Midtown Holding Leasing and Properties Pvt. Limited
(Formerly Known as Dhartidhan Granites Pvt. Ltd.)

Subject : Submission of point wise reply raised by Hon'ble EAC during 11th meeting of Expert Appraisal Committee (Infra-2) for Projects related to All ship breaking yard including ship breaking unit, Airport, Common Hazardous Waste Treatment, Storage and Disposal Facilities, Ports and Harbours, Aerial Ropeways, CETPs, Common Municipal Solid Waste Management Facility, Building/Construction Project, Townships and Area Development projects held on 24- 25th November, 2016 for the Proposed Residential and commercial development of Delta-2 at Plot No. -2, Sector- 8, Ulwe, Navi Mumbai, District, Raigad, Maharashtra by M/s. Midtown Holding Leasing and Properties Pvt. Ltd – Environmental Clearance - [F.No.21-41/2016-IA-III] listed as item number- 11.3.10.

With reference to the above subject of 11thMoM of EAC, M/s. Midtown Holding Leasing and Properties Pvt. Ltd. Project Delta-2 is located at Plot No. 2, Sector-8, Ulwe, Navi Mumbai and please note we have previously obtained Environment Clearance letter on 31st May, 2014 (SEAC-2013/CR-489/TC-1) and **this is revised application to EAC is d

Enclosure No. 11: Water Balance chart

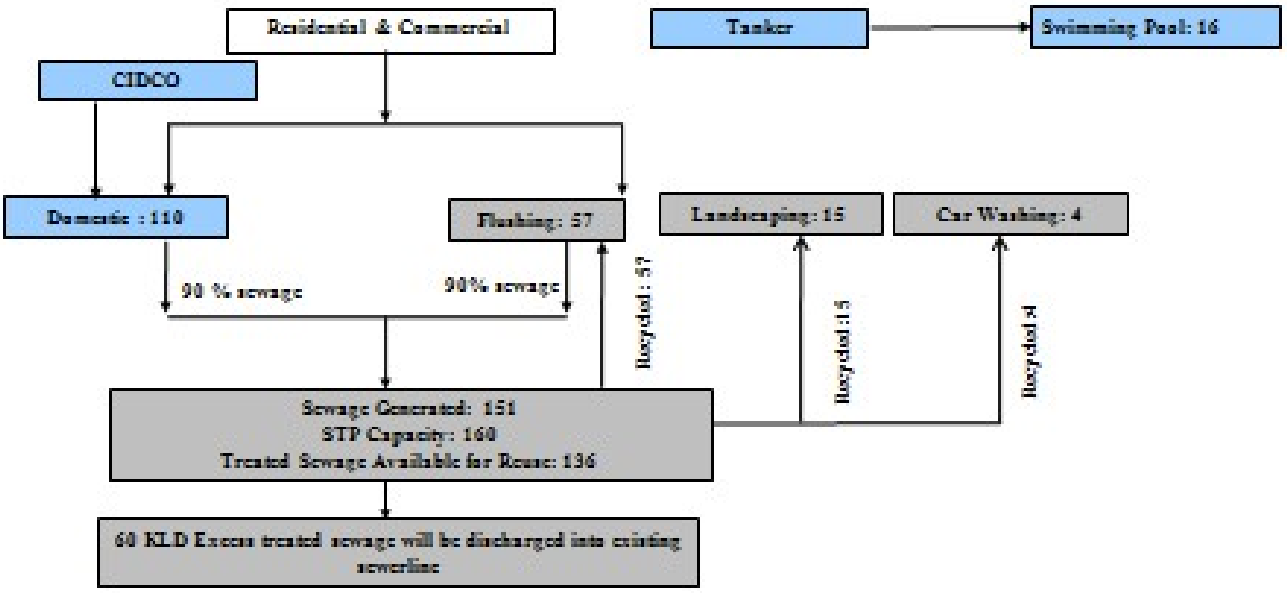
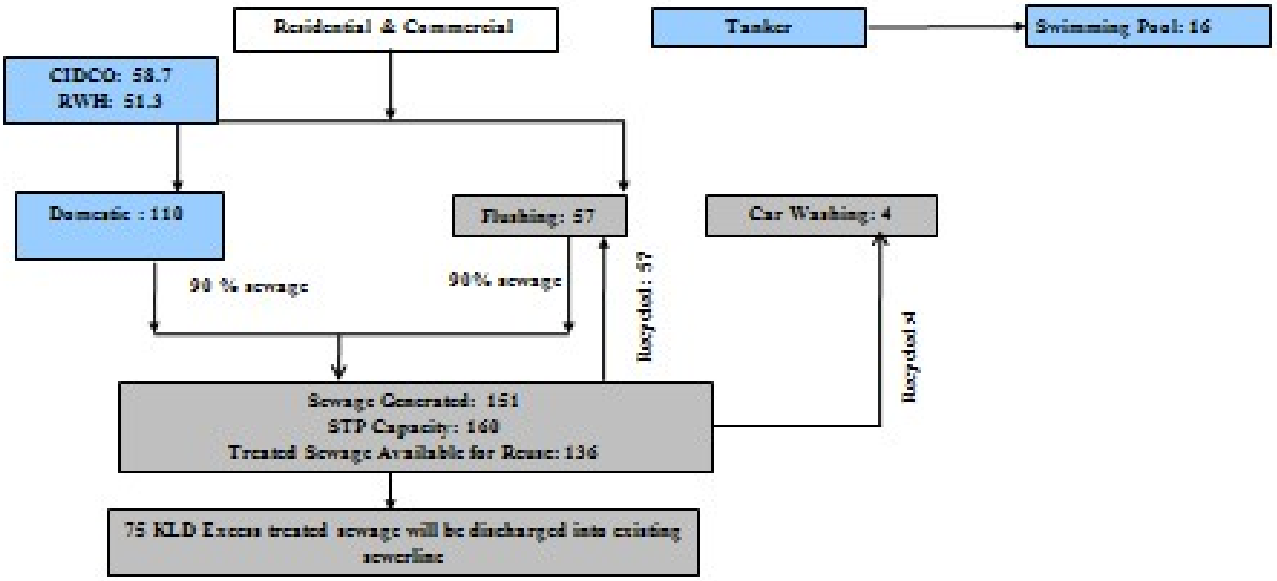
x.	Water balance chart. **Compliance:** Please refer Enclosure No. 11 for water balance chart.
xi.	Proposed scheme for treatment of sewage. **Compliance:** Wastewater generated from the site will be directly treated in STP

Total water requirement = 202
Treated sewage available for recycling= 136
[Treated sewage only from proposed STP]
After recycling treated sewage will be used for Landscaping (15.0), flushing (57.0), car washing (4.0)
Net water requirement : 110 [Source: From local authority (CIDCO) = 110 (domestic) & From STP =76]
Reduction in Net water Demand = 37.60%

Total water requirement = 187
Treated sewage available for recycling= 136
[Treated sewage only from proposed STP]
After recycling treated sewage will be used for flushing (57) & Car washing (4)
Net water requirement : 58.7 [Source: From local authority (CIDCO) = 58.7 (domestic), From RWH (51.3), From STP (61)] RWH= 51.3 for Domestic Use and STP = 61 for flushing and car washing.
Reduction in Net water Demand = 60%

Enclosure No. 12: Proposed Scheme for treatment of sewage

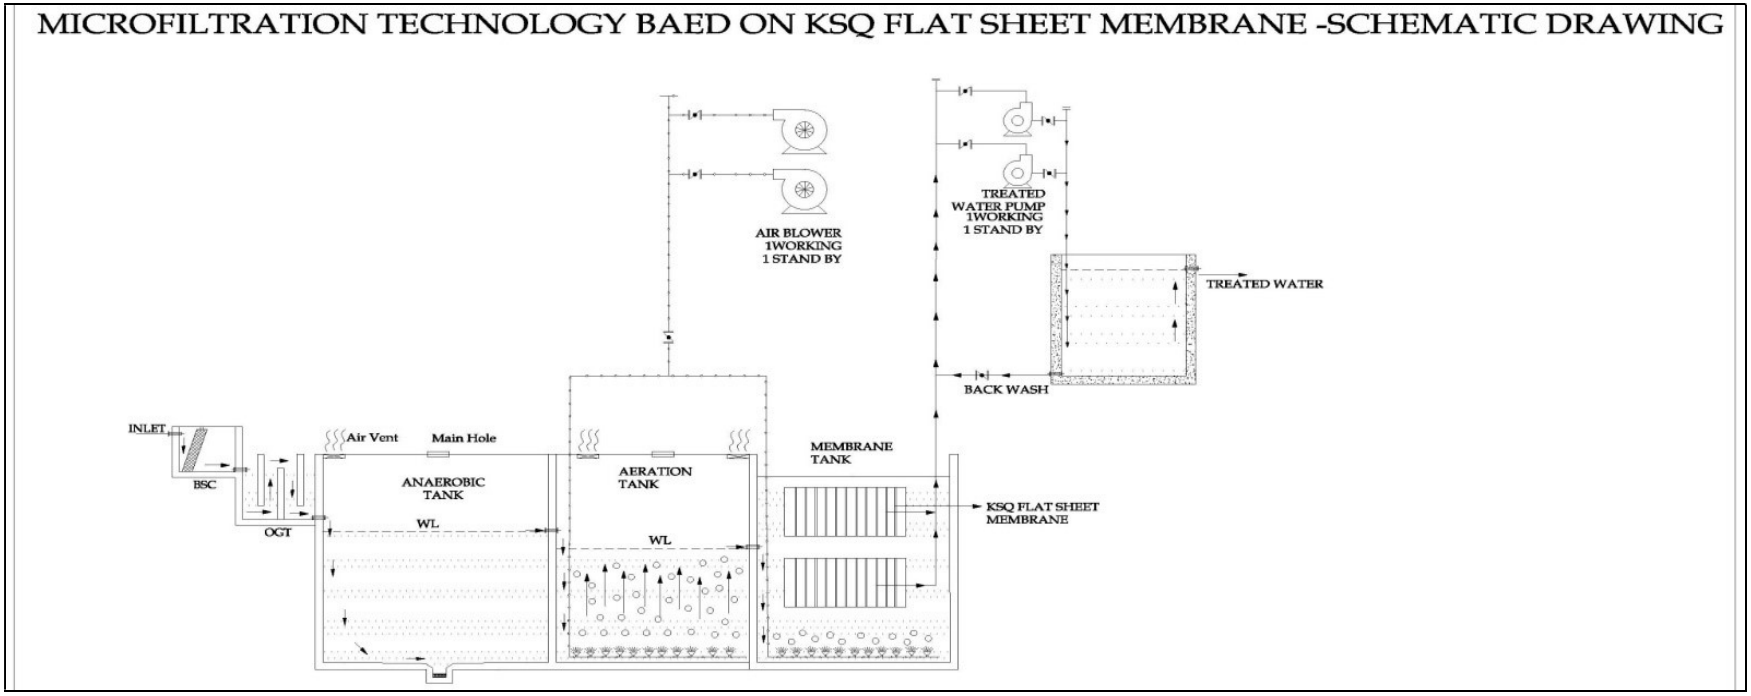
working on Microfiltration technology based on KSQ Flat Sheet Membrane. Please refer Enclosure No. 12 for proposed scheme for treatment of sewage.
xii.	Excess treated sewage disposal plan/scheme to be submitted. **Compliance:** Treated sewage shall be disposed off into NMMC municipal chamber provided outside the plot. Kindly refer attached drawing as Enclosure No. 13.
xiii.	Assessment of ground level concentration of pollutants due to DG set (4x500 kVA). **Compliance:** We have proposed for only 2 nos 200 kVA DG and not 4 nos 500 kVA (wrongly mentioned in minutes) - Please refer attached calculations in Enclosure No. 14.
xiv.	Effort shall be made to reduce capacity of DG set upto 2x500 KVA and remaining standby power shall be met from solar energy. **Compliance:** 2 DG sets 200 KVA will be provided with adequate acoustic enclosure for emergency power back up. External landscape lights and one light + one fan in each apartment are considered on solar power. Please refer attached calculations and drawing in Enclosure No. 14 for DG set details and energy conservation via solar energy.

xv.	Treatment scheme for sewage and its recycling mode. **Compliance:** STP based on Micro Filtration - KSQ Flat Sheet Membrane of 160 KLD (description along with diagram) is attached as Enclosure No.12
xvi.	Details of rain water harvesting system to be furnished. Clarity on recharge pits, storage systems for rain water and use of appropriate filtration system for collected rain water to be detailed. **Compliance:** Rainwater harvesting tank is proposed for capacity 100000 litres storage. (2 days storage is provided). Recharge pits are not provided as ground water table is high. Rain water harvested shall be treated with multigrade sand filter & carbon filter to remove suspended impurities and odour. Kindly refer Enclosure No. 15.
xvii.	Calculation on sizing of solar water heating systems to be furnished. **Compliance:** Solar water heating calculations provided. Kindly refer Enclosure No. 16.

TITLE:-
PROPOSED SOLAR PV PANEL LOCATION

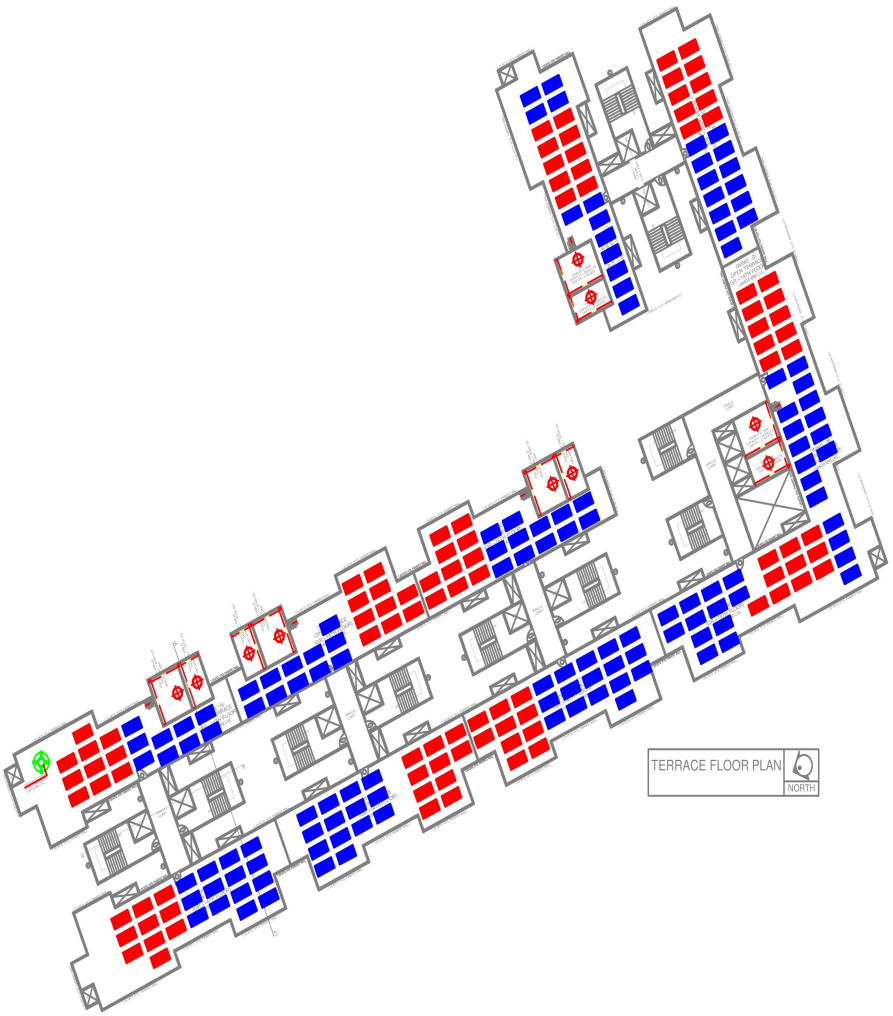
xviii.	A backup arrangement of at least 50% solar powered systems connected to the grid and at least two solar powered lights and one solar powered fan in each flat. **Compliance:** External landscape lights and one light + one fan in each apartment are considered on solar power. Please Refer attached calculations and drawing in Enclosure No. 14.

Note :- 1. Total No. of solar Panel for electrical is 130.
2. Therefore net generation will be 30kW.
2. Solar Panel for electrical is only for 1 no light and 1 no fan of each flat
